Subject: Sequoyah Fuels Corporation, SUB-1010, Docket – 40-8027
Changes To The General Arrangement Drawing

**Sequoyah Fuels Corporation
Changes to the General Arrangement Drawing**

SEQUOYAH FUELS CORPORATION	
Title: Sequoyah Fuels Corporation General Arrangement	
PREPARED BY: SFC	Filename: NRC0002E
Reviewed by: CH	
Date: 10/12/2005	Figure No.3-1

SUB-1010, Figure 3-1

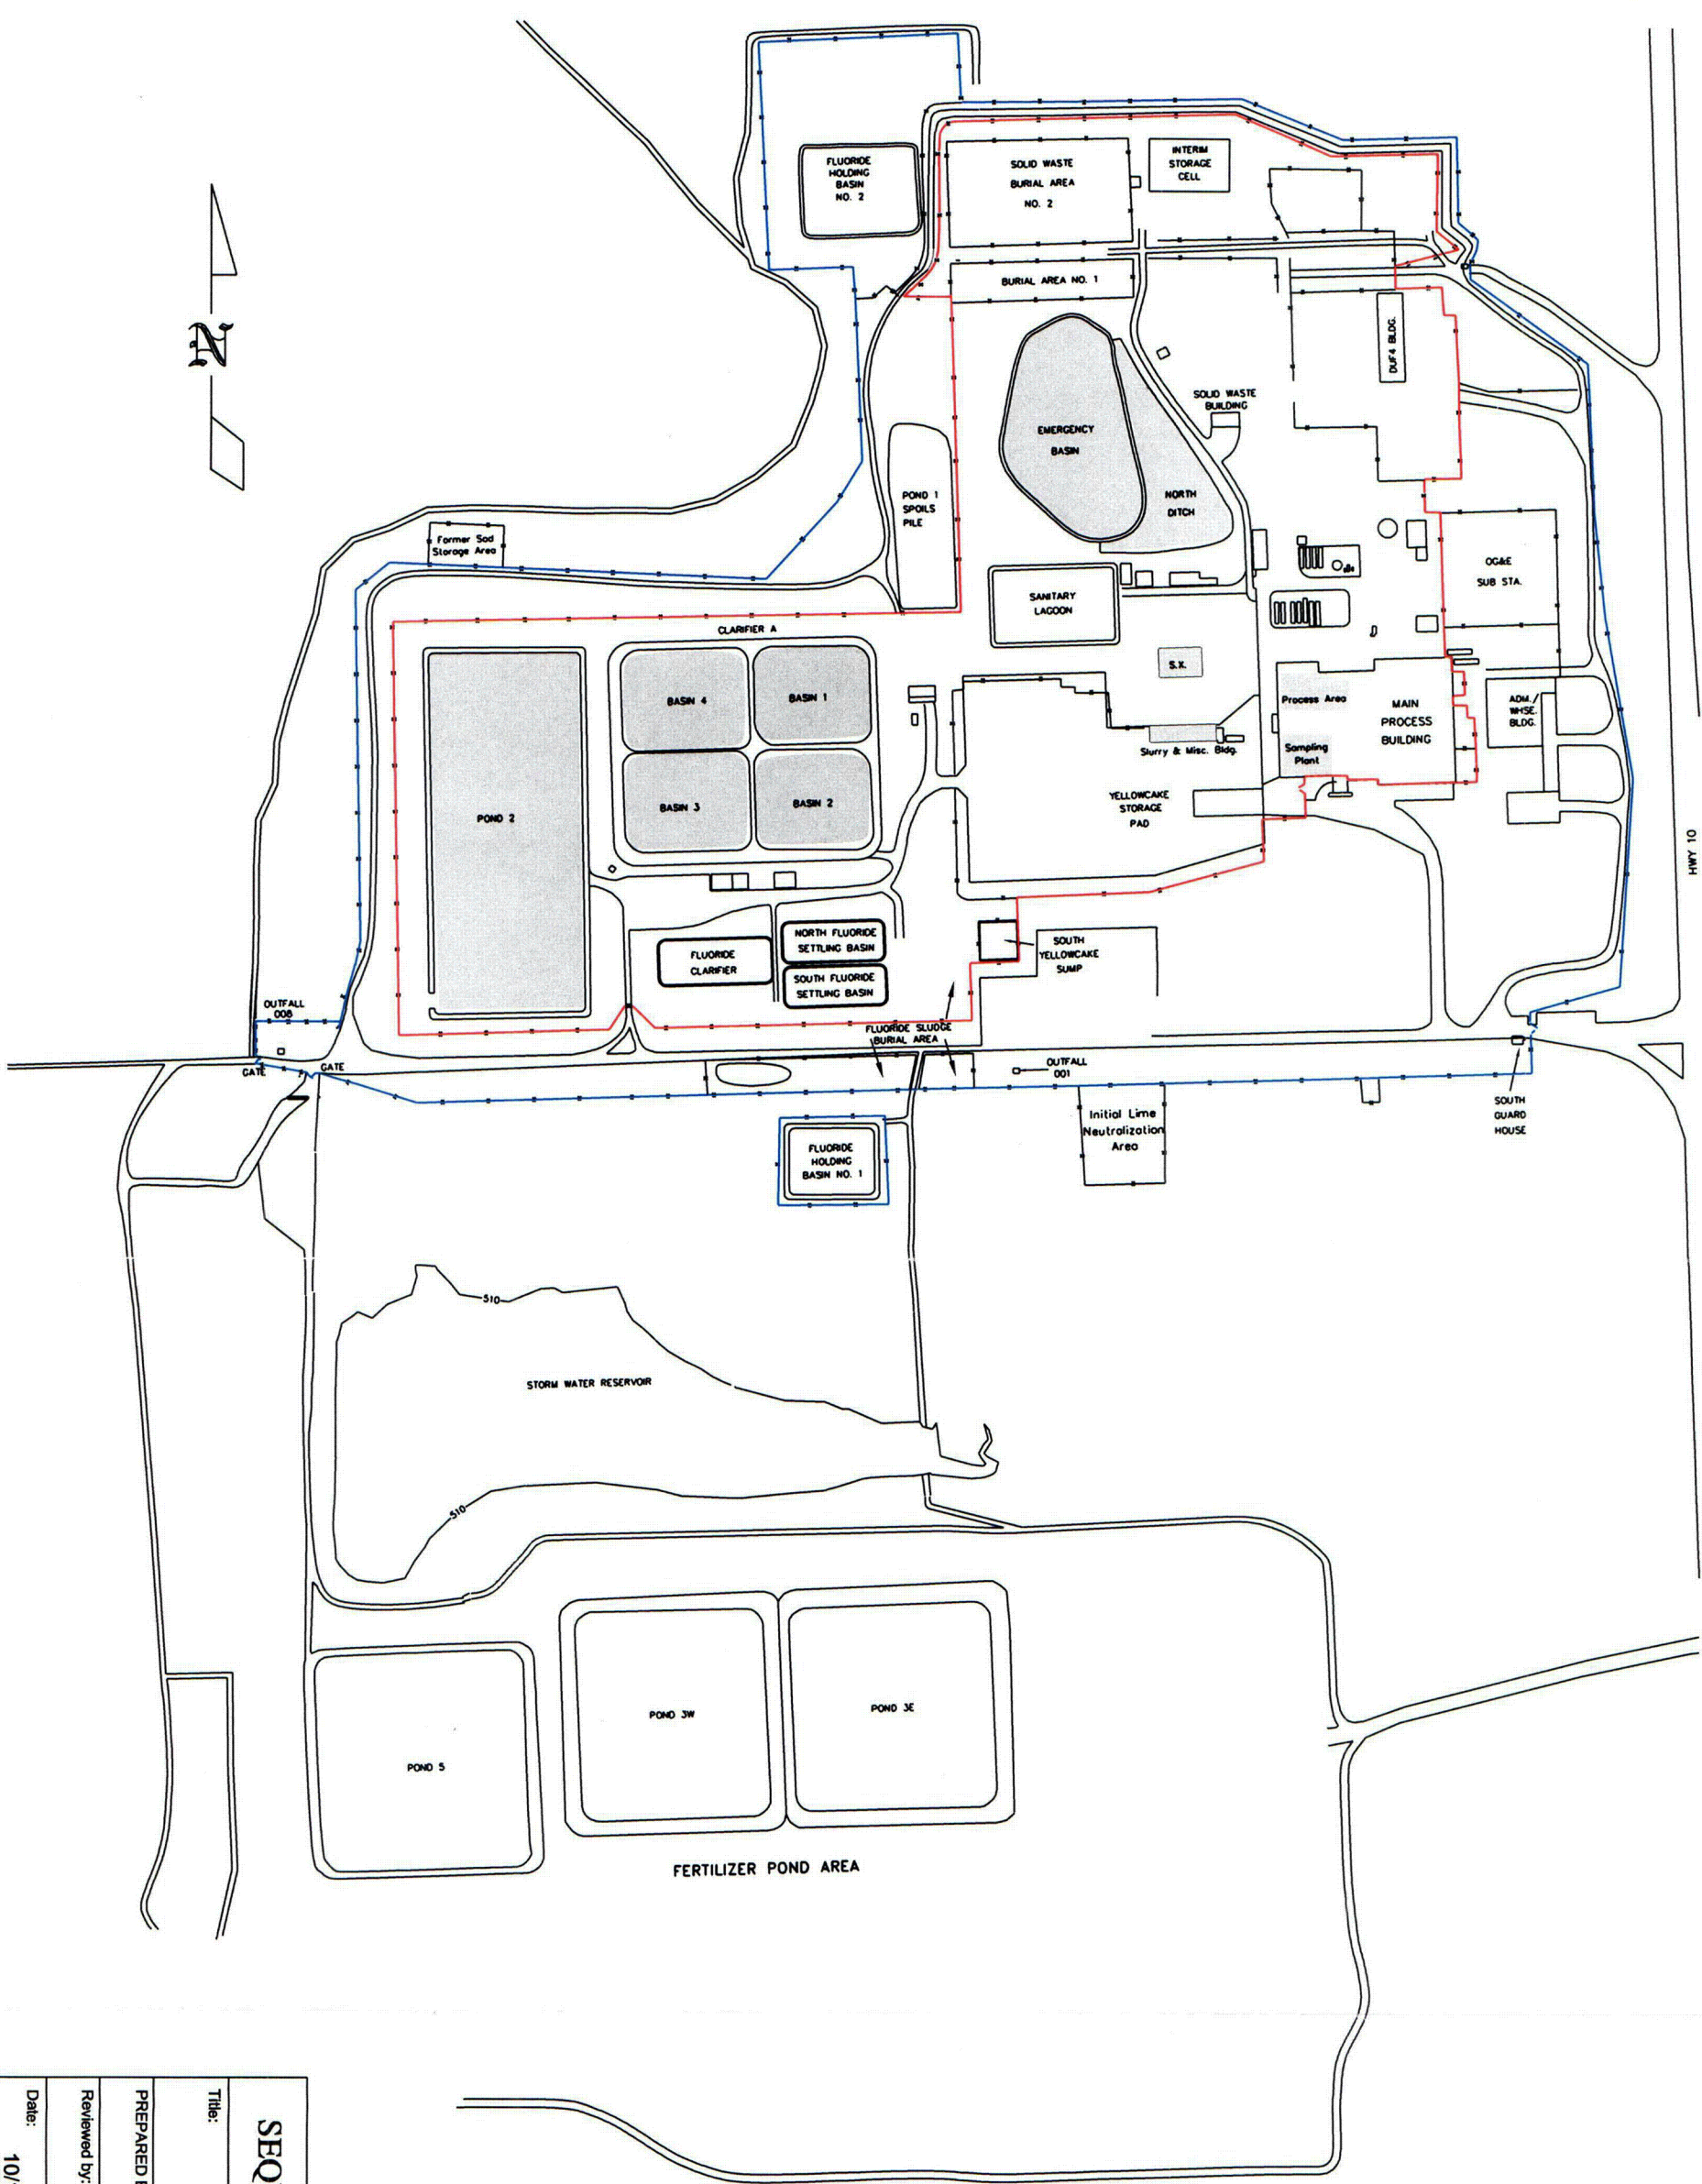
Sequoyah Fuels Corporation (SFC) has revised the General Arrangement Drawing contained in SUB-1010 due to cleanup efforts that have been completed. Pond 4, the fence around the area where Pond 4 was formerly shown, Pond 6 and the Decorative Pond have been removed from the General Arrangement Drawing to reflect current conditions at the Facility. SFC requests that Figure 3-1 of SUB-1010 license renewal application be replaced with the enclosed Figure 3-1 (Enclosure 1). No other changes to the text or conditions of the license are necessary.

Pond 4 was previously used to store licensed material and was designated as part of the Restricted Area of the Facility. Access to the pond was controlled by a fence around the pond. Pond 4 was downgraded from a Restricted Area to a Protected Area when the source materials were removed to the Process Area leaving only residual source material in the pond. SFC has removed all residual source material from Pond 4 to the Process Area, and has conducted a survey to determine the radiological status of the impoundment and surrounding area. Enclosure 2 provides the details of the Pond 4 survey. Confirmatory measurements of this area were conducted by NRC Region IV and the results are documented in IR 040-08027/05-001. The confirmatory measurements verified SFC's survey.

SFC has determined by survey that the area is well below any levels that require access control. Removing the Protected Area designation from Pond 4 is

consistent with the requirements of SUB-1010 and 10 CFR Part 20. Neither Pond 6 nor the Decorative Pond have contained source materials and thus have not been controlled historically. As such, this change in the General Arrangement drawing is administrative in nature.
